DUTCH MASTERS SUBDIVISION

Engineering Comments: FINAL PLAT COMMENTS (should be addressed prior to submitting the FINAL PLAT for review and/or signature by the City Engineer):

APPLICATION NUMBER 5 DATE July 18, 2019

DETAIL SITE PLAN

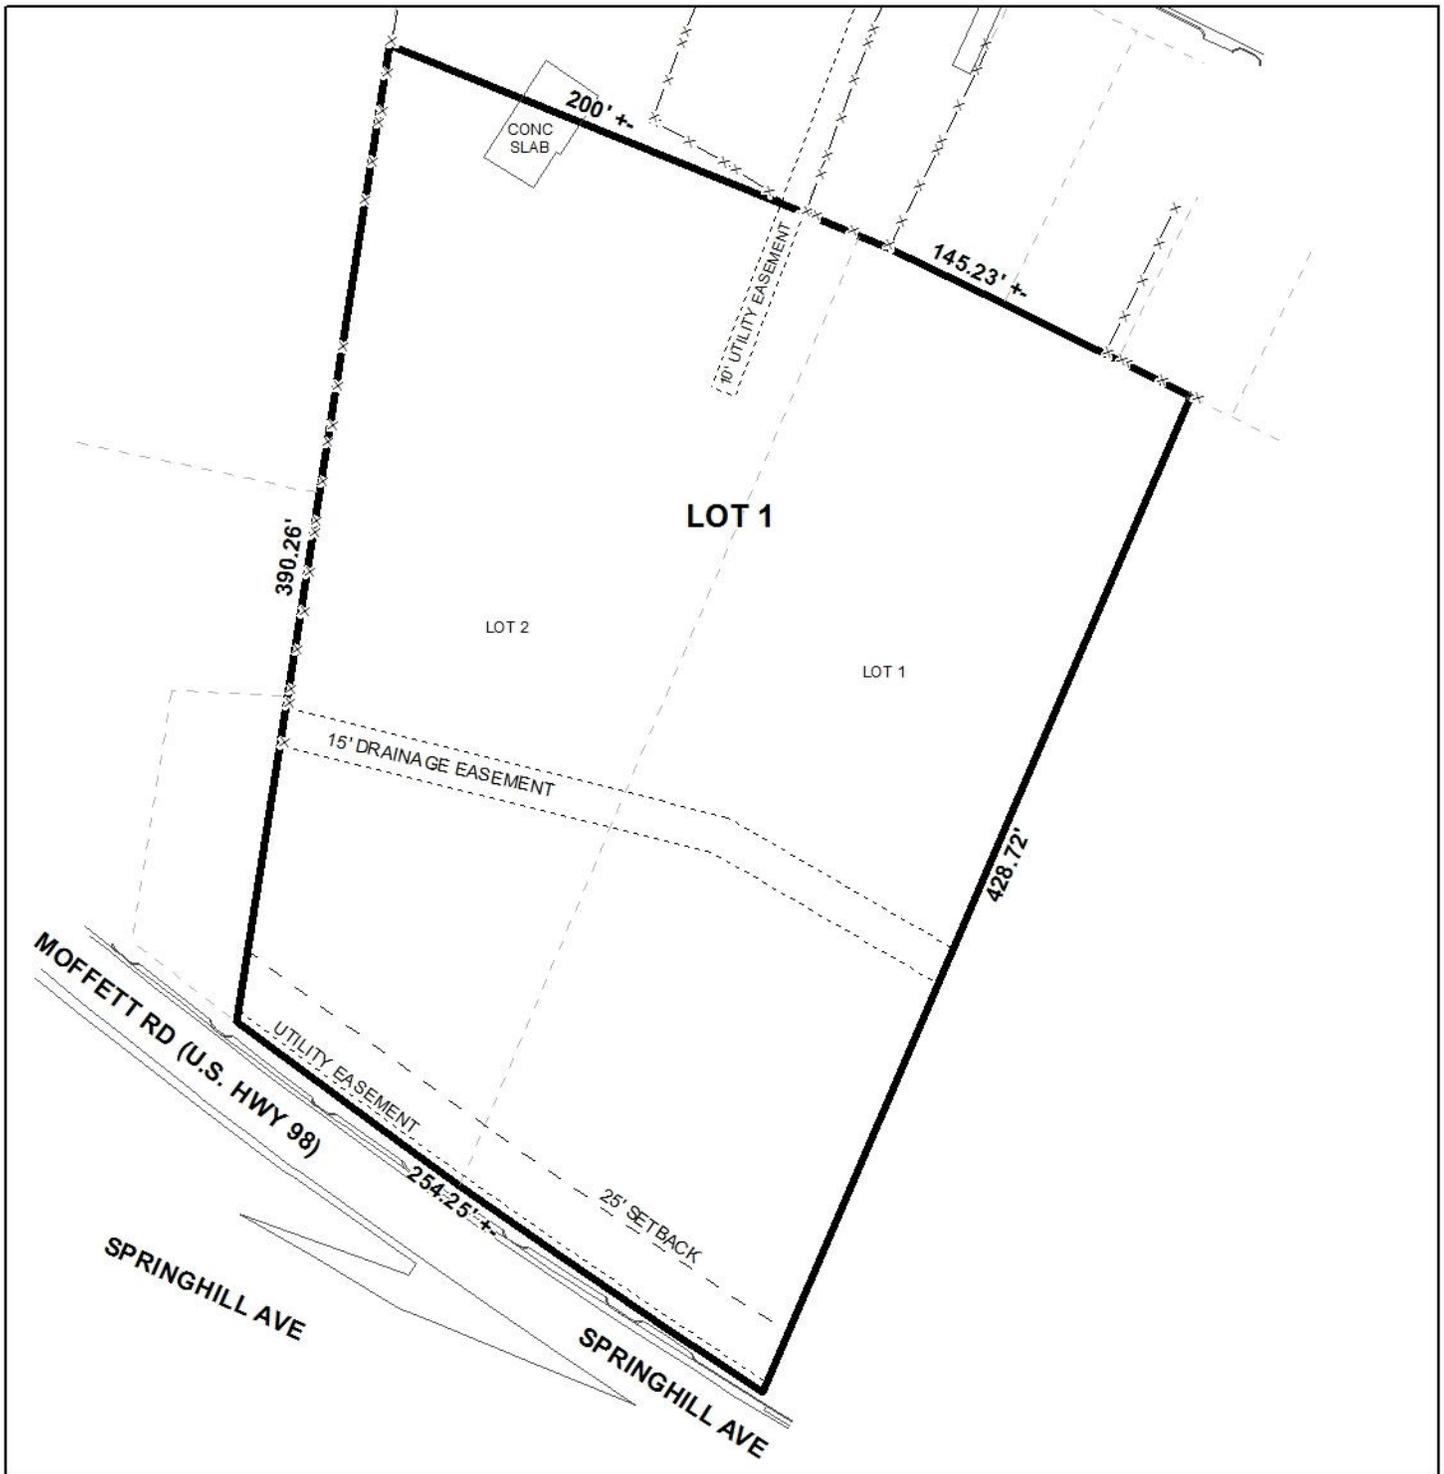
The proposed lot fronts Moffett Road (U.S. Highway 98), an ALDOT regulated, major street requiring a minimum 100' right of way width. The preliminary plat does not provide right-of-way width for Moffett Road. If approved, the Final plat should be revised to provide the appropriate right-of-way width.

A 25-foot minimum building setback is illustrated on the preliminary plat along Moffett Road. If approved, the 25-foot minimum building setback should be retained on the Final Plat.

It should be noted that there is an existing 15' drainage easement that bisects the proposed Lot 1 and a 10' Mobile Gas easement to the rear of the property. If approved, a note should be placed on the Final Plat stating that no structures shall be erected in any easement.

The proposed lots each exceed the 7,200 square foot minimum lot size requirement for lots served by public water and sanitary sewer systems. The preliminary plat provides the lot size information in square feet and acres. If approved, the lot size information should be retained on the Final Plat.

As a means of access management, a note should be placed on the Final Plat containing the Traffic Engineering comments.

- 1) Labeling of the existing right-of-way of Moffett Road;
- 2) Retention of the 25' minimum building setback line along Moffett Road;
- 3) Retention of lot size information in both square feet and acres;

- 4) Placement of a note stating that no structure shall be erected in any easement;
- 5) Placement of a note on the Final Plat stating the following Traffic Engineering comments: (*"Moffett Road (US Highway 98) is an ALDOT maintained roadway. Site is limited to one curb cut with size, location and design to be approved by ALDOT and Traffic Engineering and conform to AASHTO standards. Any new on-site parking, including ADA handicap spaces, shall meet the minimum standards as defined in Section 64-6 of the City's Zoning Ordinance."*);
